RESPONSE TO REQUEST FOR ADDITIONAL INFORMATION

APR1400 Design Certification

RAI No.: 390-8479
SRP Section: 12.02 – Radiation Sources
Application Section: 12.02
Date of RAI Issue: 02/01/2016

Question No. 12.02-27

Table 12.2-25 (3 of 3)

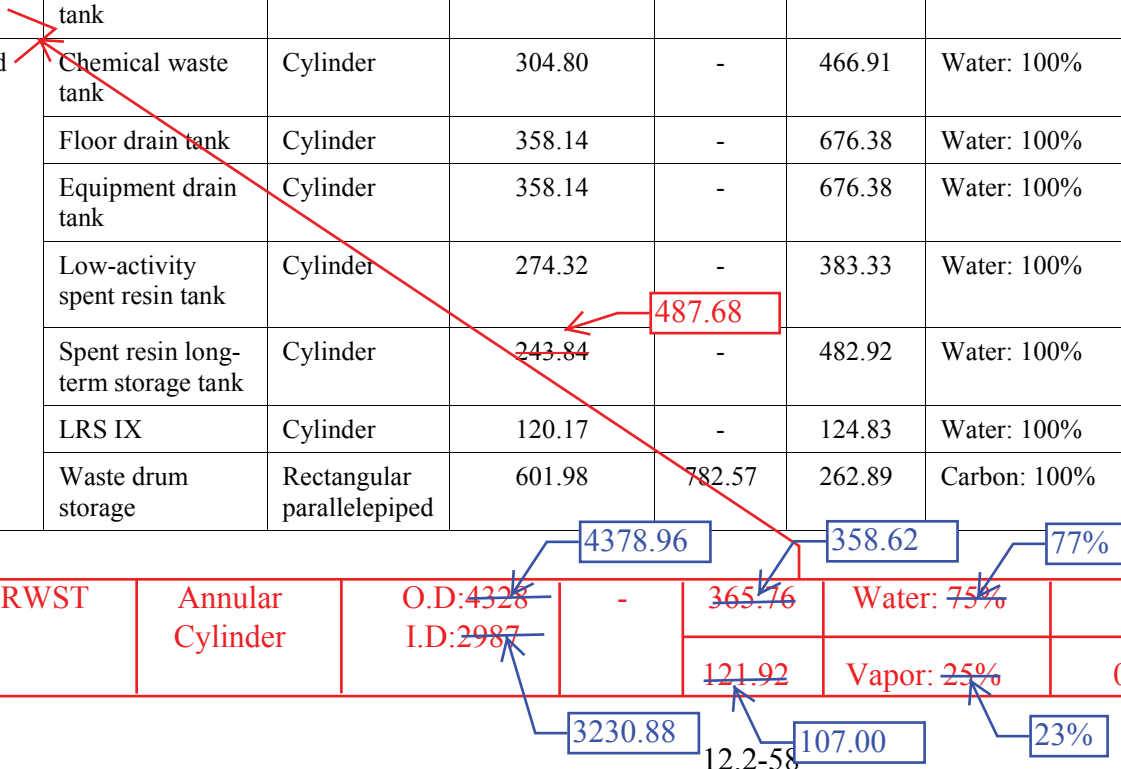
2. In performing confirmatory calculations to attempt to verify if the results provided in the FSAR were still adequate (with the changes), the staff noticed that the water volume assumed for the IRWST in 11E47-I-035-N377-013, used for calculating airborne activity from leaked IRWST fluids, was inconsistent with the normal water volume of the IRWST provided in FSAR Chapter 6, Table 6.8-1. In addition, the IRWST volume provided in the response to RAI 7856, Question 12.02-2 is also different. Please explain these discrepancies in IRWST water volume and ensure that the Chapter 12 source term information and estimated airborne activity concentrations associated with the IRWST are based on the normal operating water volume and concentrations, provided in FSAR Table 6.8-1 (with an estimated 0.25% fuel failure percentage), or are more conservative. Provide all revisions to the calculations and FSAR that are appropriate.

2. The IRWST volume of 649,000 gal provided in DCD Table 6.8-1 represents the normal operating volume and is based on the useful volume of the tank between the lower water level and normal water level; the useful volume does not include the volume from the tank bottom to the lower water level and the sump volume.

The shielding calculation considers the IRWST geometry, from the bottom of the tank to the normal water level. Also, the IRWST volume used in 11E47-1-035-N377-013 considers the entire IRWST inventory, from the tank bottom to the Hi alarm point which is higher than normal water level.

However, the IRWST volumes used in the shielding calculation and the IRWST concentration calculation are inconsistent and not conservative values. Therefore, the IRWST shielding and the concentrations were recalculated with the volume of 649,000 provided in DCD Table 6.8-1. Calculation 11E47-1-035-N377-013 was updated and the changed airborne radioactivity concentration and the Derived Air Concentration (DAC) fraction in Table 12.2-23 is provided in Attachment 1. The sum of the DAC fractions is still within the acceptable range (i.e., less than 1); and the changes do not impact on the actual ventilation flows in the original HVAC design. The IRWST volume provided in Table 12.2-25 will also be changed in Attachment 2.

DCD Tier 2 Table 12.2-25 will be updated as indicated in Attachment 2.
